SUBJECT: Forwards response to NRC questions re long term seismic program geology, seismology & geophysics issues.

Re: Docket No. 50-275, OL-DPR-80  
Docket No. 50-323, OL-DPR-82  
Diablo Canyon Units 1 and 2  
Long Term Seismic Program - Geology/Seismology/Geophysics

**RESPONSE TO GSG QUESTIONS  
LP 2 THROUGH LP 8 AND LP 10 THROUGH LP 13**

**Diablo Canyon Power Plant  
Long Term Seismic Program**

Figure LP Q2-1

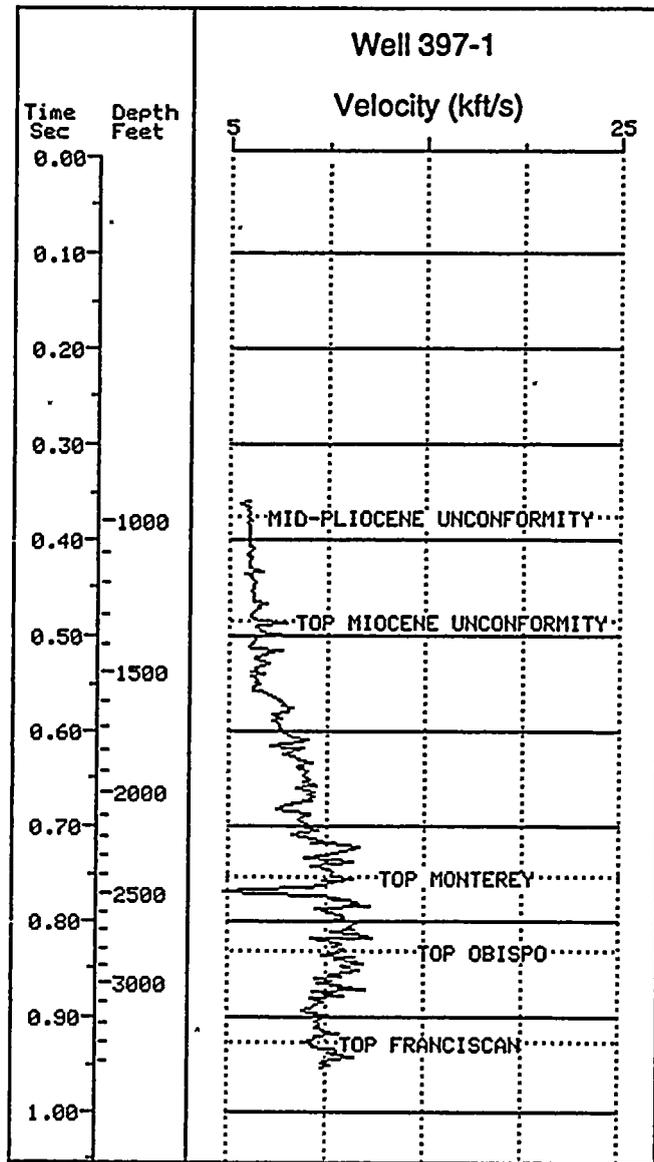
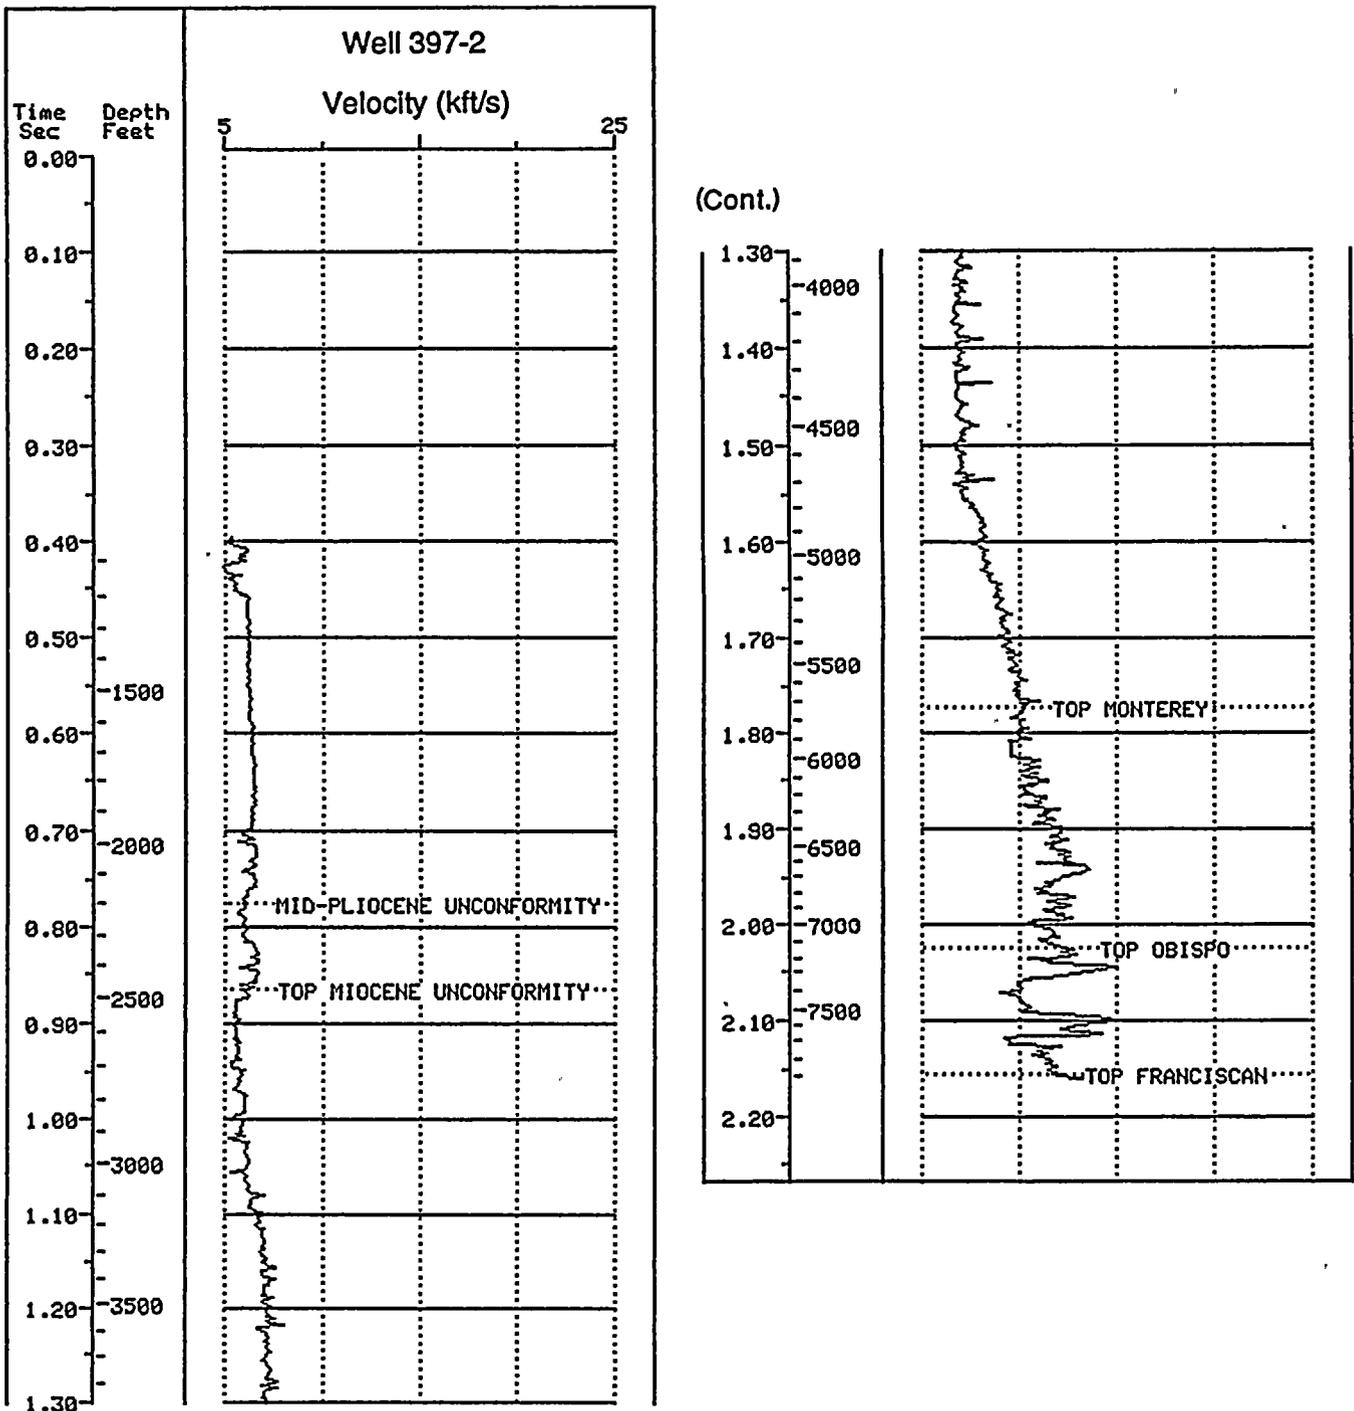
**QUESTION LP 2**

Sonic logs are available from Phillips wells 397-1 on the east side of the Hosgri fault zone, and 397-2 on the west side (Figures LP Q2-1 and LP Q2-2). These two wells are approximately 3.5 kilometers apart, about 15.5 kilometers northwest of Point Sal. The wells are discussed further in the Response to Question LP 6, and their locations are shown on Figure LP Q6-1, as well as on the panels for the Point Sal montage. The thinner Monterey and upper Miocene sections on the east side of the Hosgri are evident. Average velocities for the horizons marked on the logs compare favorably between the wells and with the layer-cake model used in the depth conversions. Of course there is a much thicker section of mid- to late-Miocene rocks on the west side of the Hosgri fault zone, but changes in thickness are accommodated directly in the conversion process. The velocities used in the models are presented in Table LP Q2-1 and can be compared with those from the Phillips wells.

Velocity versus depth curve from Phillips well 397-1 on the east side of the Hosgri fault zone. Velocity data are from a sonic log. Horizon boundaries are marked at depths interpreted by PG&E based on additional well log data. Refer to the Response to Question LP 6 for a discussion of the criteria used to identify horizon depths in the wells.

Velocity versus depth curve from Phillips well 397-2 on the west side of the Hosgri fault zone. Velocity data are from a sonic log. Horizon boundaries are marked at depths interpreted by PG&E based on additional well log data. Refer to the Response to Question LP 6 for a discussion of the criteria used to identify horizon depths in the wells.

Figure LP Q4-4

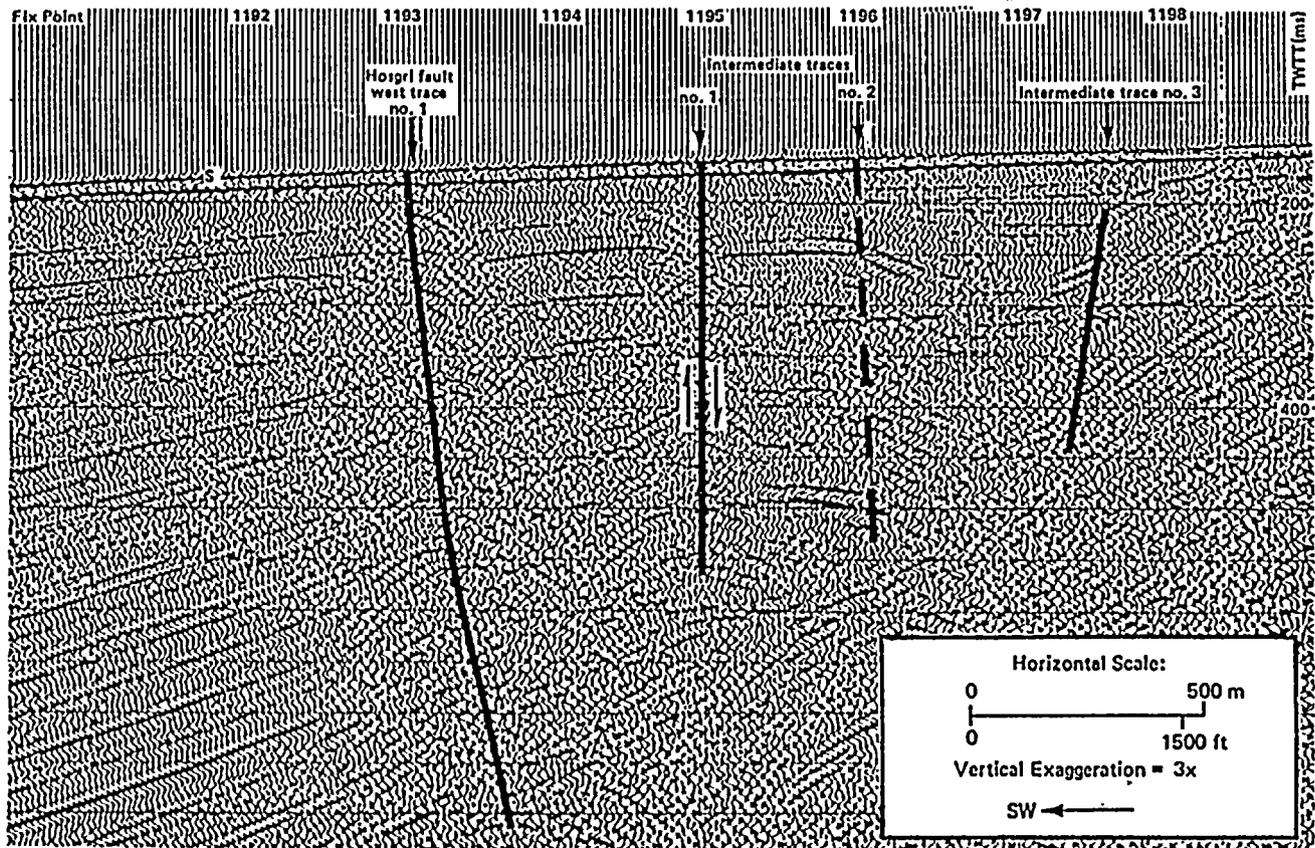
**QUESTION LP 4**

Evidence for the disruption and distortion of the shallow sediment horizons within this area is documented in the tables and on Figures H-62 through H-82 of Section 13 of Attachment Q43-1, submitted in January 1989. Figure LP Q4-4 is a copy of Figure H-63a from that attachment. Diffraction cones are evident on the west trace and intermediate trace no. 1. Changes in bedding plane dips and vertical positions of the horizons in the zones between the several traces are also evident. Pervasive evidence of this nature supports the conclusion that there are steeply dipping fault planes and that the gas is migrating upward locally along the fault planes. Detailed observations and comments about similar features seen on the GSI common-depth-point lines are presented in Response to Question LP 3 and in Figures LP Q3-2 through LP Q3-11, comparing processing results.

Fairfield line 180, Fairflex sleeve, common-depth-point record from the vicinity of montage profile Q-Q' in the San Luis Obispo Bay reach. Diffraction cones suggest gas is migrating upward along the two western traces at this location. Note the changes in bedding plane dips.

- Pervasive evidence of localized deformation along the vertical traces of the Hosgri fault zone cannot be explained as gas-related anomalies. This evidence is seen not only on the high-resolution records (Figure LP Q4-4 and the Tabulation of Observations, PG&E, 1988), but also on the common-depth-point records (Figure LP Q4-4, Figures LP Q3-2 through LP Q3-11, and the montage panels).

Figure LP Q5-1

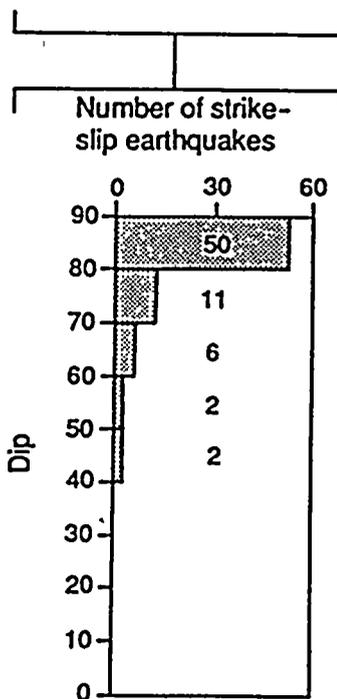
*During the discussion of the question of the possibility of strike slip motion on a non-vertical fault at the meeting it was noted that, there is at least one example, the Xieshi He fault zone in China, of a moderately dipping fault which accommodated reverse displacement in early Quaternary time and has more recently been reactivated as a strike-slip fault. Are there many cases of moderately dipping active strike-slip faults? Is there any evidence for this type of history for the Hosgri fault? What impact would this have on the resultant source characterization and ground motion for Diablo Canyon? (Dipping strike-slip faults have been previously identified as causes of high ground motion.)*

To address the question of nonvertical strike-slip faults, we reviewed published focal mechanisms for 160 earthquakes worldwide to evaluate fault dip and rake. The best constrained mechanism for each earthquake is listed in Table LP Q5-1. Focal mechanisms determined by waveform inversion (P and SH) are generally better constrained than P-wave first-motion solutions, thus the former are generally preferred. Because we are only interested in the relative components of strike slip and normal or reverse slip, and not the left/right direction of slip, we normalized all rake angles from these focal mechanisms into a measure from -90 to 90 degrees. Figure LP Q5-1 is a plot of rake angle versus dip for the worldwide earthquakes examined in this analysis.

Figure LP Q5-1 clearly shows that the rake angle derived from earthquake focal mechanisms increases with decreasing dip of the fault plane. Strike-slip earthquakes typically occur on steeply dipping faults, dip-slip earthquakes occur on more shallowly dipping faults. The data indicate that the occurrence of strike-slip earthquakes on moderately dipping faults (dips of 70 degrees or less) is uncommon. Specifically, only 14 percent (10 of 71) of the strike-slip earthquakes appear to have occurred on faults that dip less than 70 degrees, and only 6 percent (4 of 71) on faults that dip less than 60 degrees (Figure LP Q5-1). In the following section, we further examine the 10 strike-slip earthquakes that appear to have occurred on faults dipping less than 70 degrees. In particular, we have evaluated the applicability of these earthquakes to the tectonic setting of coastal central California and have assessed the quality of the data used to constrain the focal mechanisms and fault geometry. We also examine two moderately dipping oblique-slip earthquakes that have a significant strike-slip component.

Plot of fault dip and rake for earthquakes given in Table LP Q5-1. Values are best-supported estimates; rakes have been normalized to values between 0 and 90 degrees.
